Report to the Planning and Zoning Commission

Case: Z2006024 Utility Construction Company, Inc.

Meeting Date: October 5, 2006

Request: Major Amendment to a Precise Plan of Development in IND-3 IUPD zoning district

[photo of the existing site Warner Rd. on next page.]

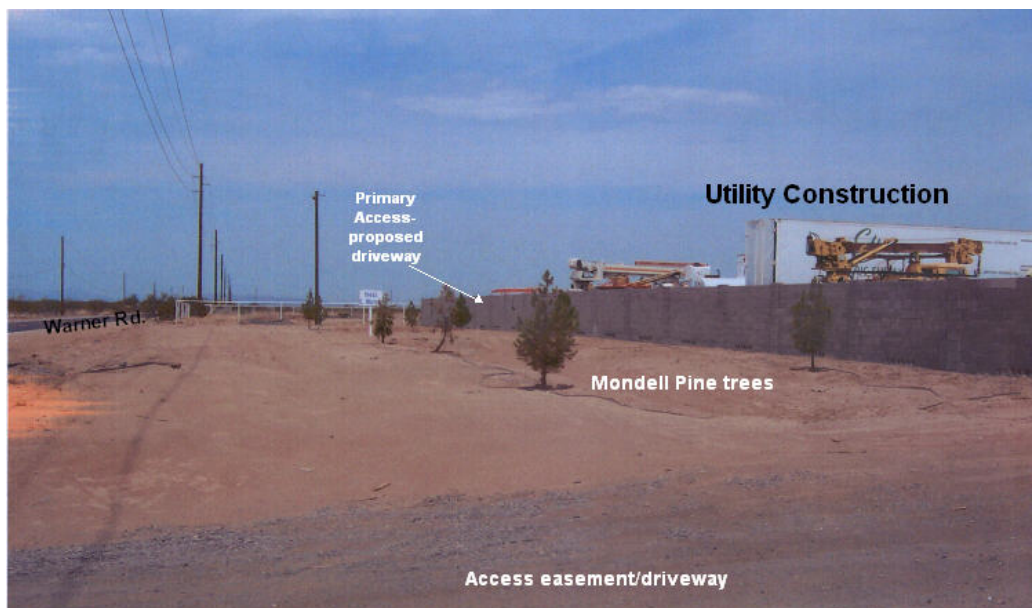
49. While it could be argued that once developed, the area will be primarily industrial in nature and therefore does not warrant extra effort or expense spent on such items as screening and landscaping. Staff would note that this area will soon be developed with a similar freeway alignment, which could also make this area quite visible, if not from the freeway itself, but due to the increase in traffic getting to and from the freeway. Staff, therefore, believes it important to encourage enhanced site designs and streetscapes when possible in order to mitigate the appearance of industrial blight. The Z2004019 IUPD provided relief from the solid wall fencing required adjacent to residential zoning districts by allowing slatted chain-link fencing on the north, east, and west sides. There is an existing 6' (h) CMU block wall along Warner Rd.

- The proposal is to tear down most of the block wall and use the building and slatted chain-link fencing to obscure the site. Staff sees no benefit in this approach. An argument can be made not to support the City of Mesa request for sidewalks, parking lot landscaping, and foundation plantings when the view of the parking lot is obscured by the solid wall. Requiring a solid perimeter wall along Warner Rd. would seem to be a minor concession, especially in view of the fact the wall already exists.

- The applicant argued in their original zoning case that adjacent properties were not required to build a wall. There is no support for that argument. The City has stated that they would make the same request any construction yard along Warner Rd. The City of Mesa did not consider the new car distribution center (PDI) (east) to be a construction yard, but rather would look more like a new car sales lot and, therefore, the wall was not requested. In addition, the PDI site would have a landscape buffer and retention area along Warner Rd. with the Mondell Pines.

- The applicant has stated that construction of the site will not interfere with the Mondell Pines that have been planted along the front setback. If the pine trees will not be disturbed, then there is no reason why the wall would have to be disturbed, except for construction of the west driveway and sight visibility triangles (SVTs). A solid wall will obscure the view of the parking, and the construction yard. Therefore, staff has included a stipulation that the existing CMU wall along Warner Rd. remains on the site, with the exception of the driveway and SVTs, and if damaged during construction, should be replaced.

- f. With the exception of the proposed driveway and sight visibility triangles (SVTs), the existing 6' (h) concrete masonry wall (CMU) shall be retained along the Warner Road frontage. If said wall is damaged during construction, it shall be replaced with a similar wall.
